STAFF REPORT
COMMUNITY DEVELOPMENT DEPARTMENT

HEARING: May 18, 2021
 DATE: *Continued from: March 9 and April 13, 2021*
 TO: Mayor & City Council
 FROM: Sonya Allen, Associate Planner
 208-884-5533
 SUBJECT: H-2020-0117
 Shafer View Terrace – AZ, PP
 LOCATION: East side of S. Meridian Rd./SH 69, midway between E. Amity Rd. and E. Lake Hazel Rd., in the SW ¼ of Section 31, T.3N., R.1E. (Parcels #R7824220044 & #R7824220042)

Annexation of a total of 40.48 acres of land with R-2 (10.66 acres) and R-4 (29.82 acres) zoning districts; and Preliminary Plat consisting of 50 buildable lots and 10 common lots on 39.01 acres of land in the R-2 and R-4 zoning districts.

B. Preliminary Plat & Phasing Plan (date: ~~11/18/2020~~ 3/9/2021)

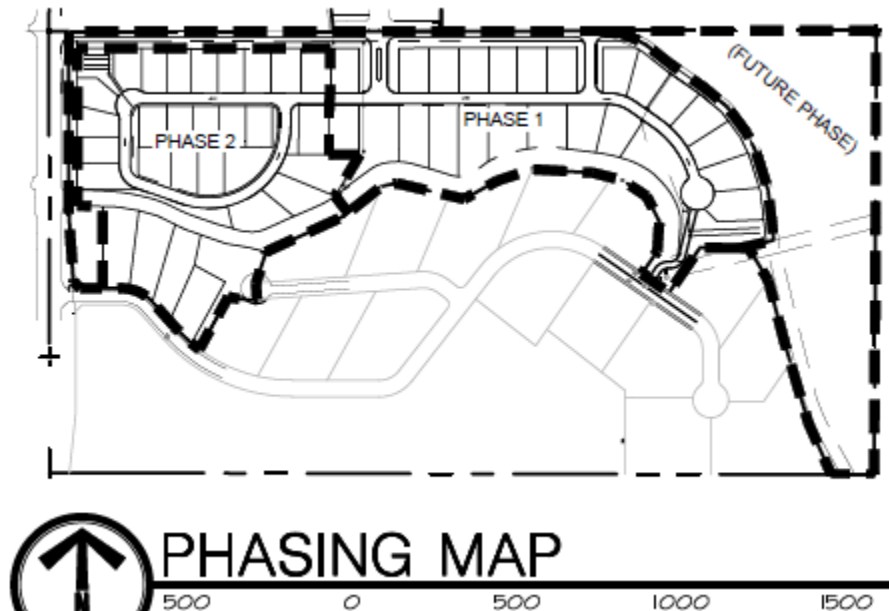
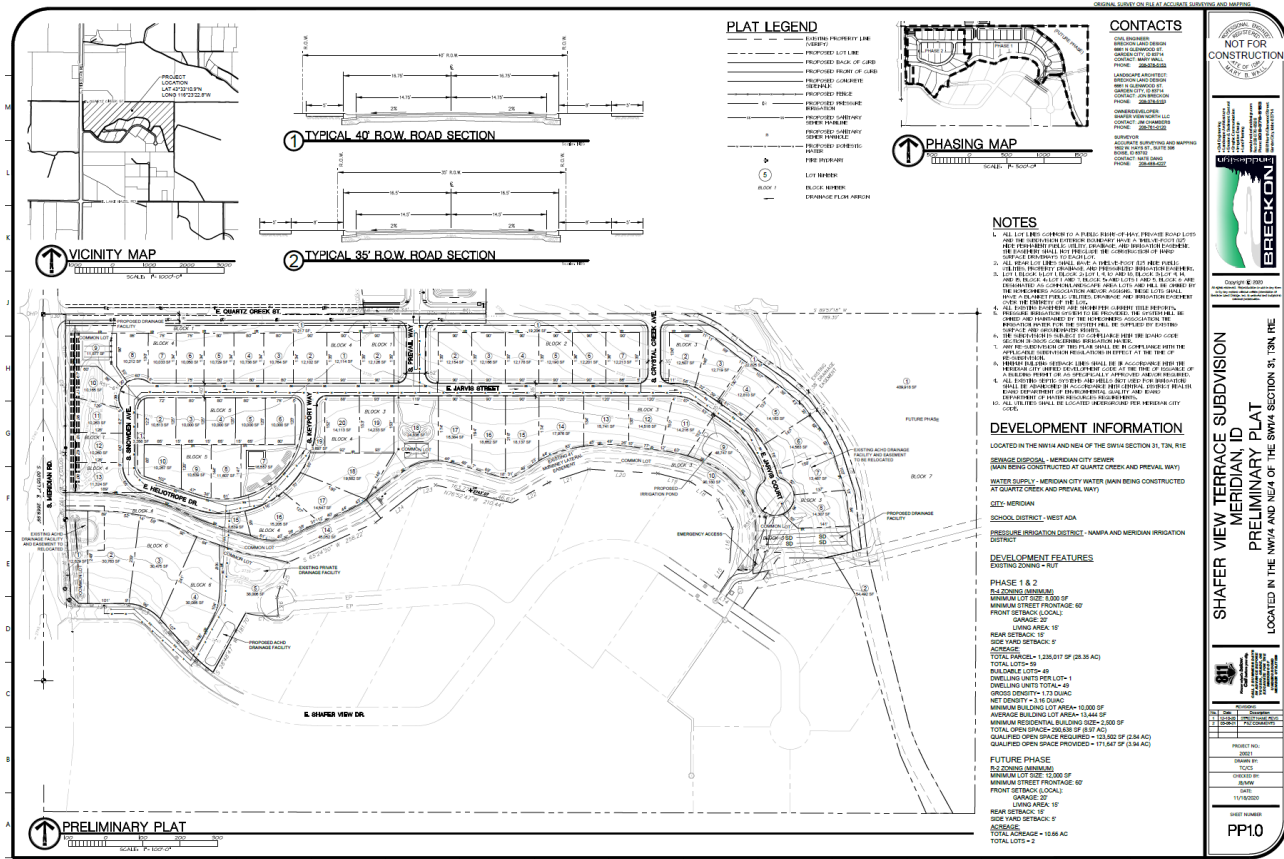
The face of Block 3 exceeds 1,200' and does not provide a pedestrian connection other than the emergency access driveway which may serve as a pedestrian connection between the proposed subdivision and Shafer View Estates to the south. **The Applicant requests City Council approval of the proposed block length due to existing site constraints that include the following: 1) the narrow configuration of the subject property; 2) the location of the McBirney Lateral, a large waterway/irrigation facility, that runs along the southern boundary and through the western portion of the proposed subdivision; and 3) the existing Shafer View subdivision that abuts the site to the south, south of the lateral, which does not include any pedestrian pathways or stub streets to this property. If not approved, the plat should be reconfigured to comply with this standard. An emergency access road for Fire Dept. is proposed between the end of the cul-de-sac and E. Shafer View Rd. but it's not a public access.**

- a. At Staff's request, include a condition for the 38' wide slough/drain on the eastern portion of the site to be contained entirely within a common lot(s) with fencing required on both sides of the drain consistent with the standards in UDC 11-3A-7A.7b per UDC 11-3A-7A.7a;

- e. Include a condition for one (1) buildable lot to removed in the area of Lots 2-5, Block 6 south of the McBirney Lateral.
- 5. Outstanding issue(s) for City Council:

- b. Block 3 exceeds the maximum block face standards listed in UDC 11-6C-3F; the plat shall be revised to comply with these standards unless otherwise approved by City Council. *A waiver is requested from Council to exceed the maximum block face allowed of 1,200 feet to allow the block face as proposed.*

- ~~c. The 38' wide drain on the eastern portion of the site shall be contained entirely within a common lot(s). Depicted on revised plat.~~
 - ~~d. Remove one (1) buildable lot in the vicinity of Lots 2-5, Block 6 south of the McBirney Lateral. Depicted on revised plat.~~

- ~~h. Remove one (1) buildable lot in the vicinity of Lots 2-5, Block 6 south of the McBirney Lateral consistent with that shown on the revised preliminary plat.~~ ~~Done~~

C. Landscape Plan (date: 5/17/2020 ~~2/3/2020~~ 3/9/2021)

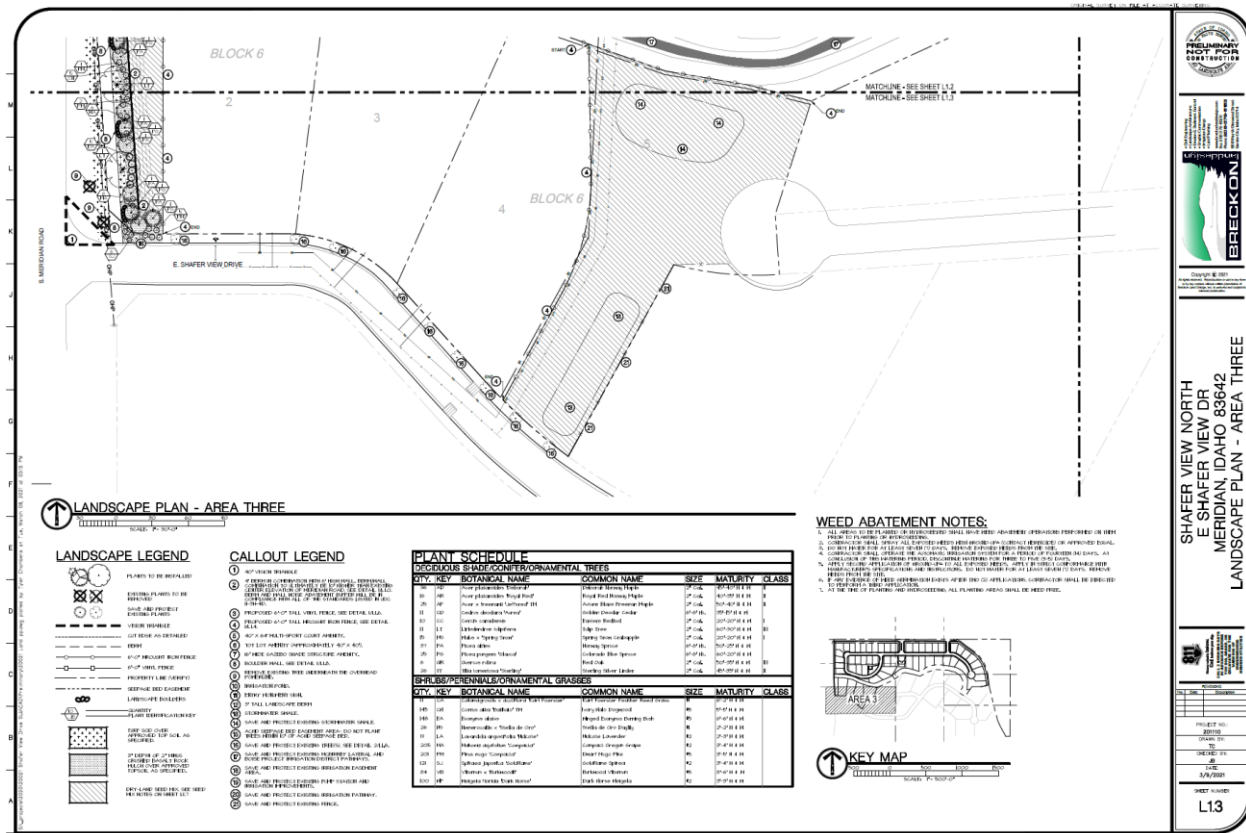
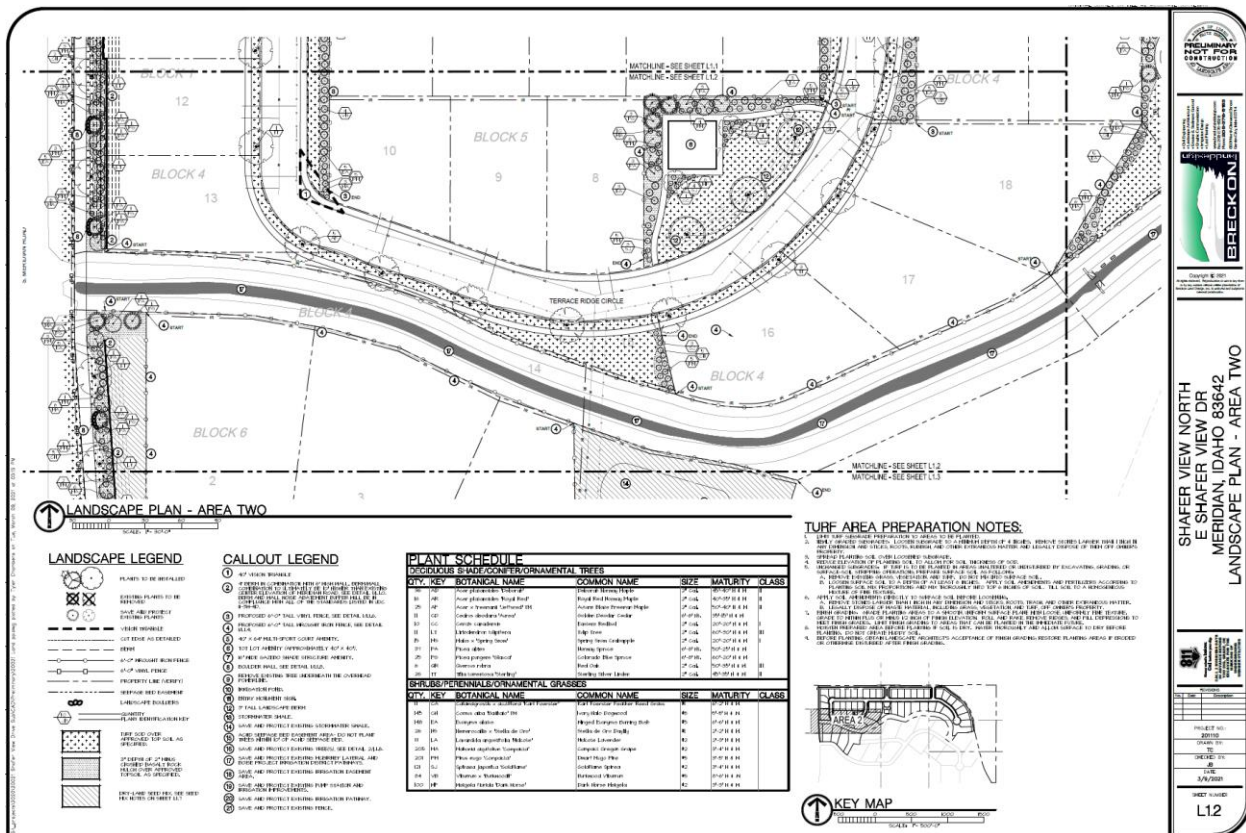
Landscaping is required adjacent to the pathway along S. Meridian Rd./SH-69 per the standards in UDC [11-3B-12C](#). A 5' wide landscape strip is required on both sides of the pathway planted with a *mix* of trees, shrubs, lawn and/or other vegetative ground cover. **The Landscape**

Requirements table should include the linear feet of pathway with the required vs. proposed number of trees to demonstrate compliance with UDC standards.

Landscaping is required within parkways per the standards listed in UDC [11-3A-17](#) and [11-3B-7C](#). **The Landscape Requirements table should include the linear feet of parkways within the development with the required vs. proposed number of trees to demonstrate compliance with UDC standards.**

A 4-foot tall berm with a 6-foot tall solid wall by Simtek is proposed along S. Meridian Rd. as noise abatement as depicted on the detail on Sheet L1.0 of the Landscape Plan. Architectural elements are proposed to break up monotonous wall planes as required. **~~A detail of the proposed wall that demonstrates compliance with the standards listed in UDC 11-3H-4D should be submitted with the final plat for the first phase of development.~~** *Depicted on the revised landscape plan.*

4. The landscape plan included in Section VII.C ~~submitted with the final plat~~ shall be revised as follows:
 - a. ~~Include calculations in the Landscape Requirements table that demonstrate compliance with the standards for pathway (11-3B-12C) and parkway (11-3B-7C) landscaping; include required vs. provided number of trees. Done~~

- c. ~~Include a detail of the berm and wall required for noise abatement along S. Meridian Rd./SH-69 that demonstrates compliance with the standards listed in UDC 11-3H-4D. Done~~
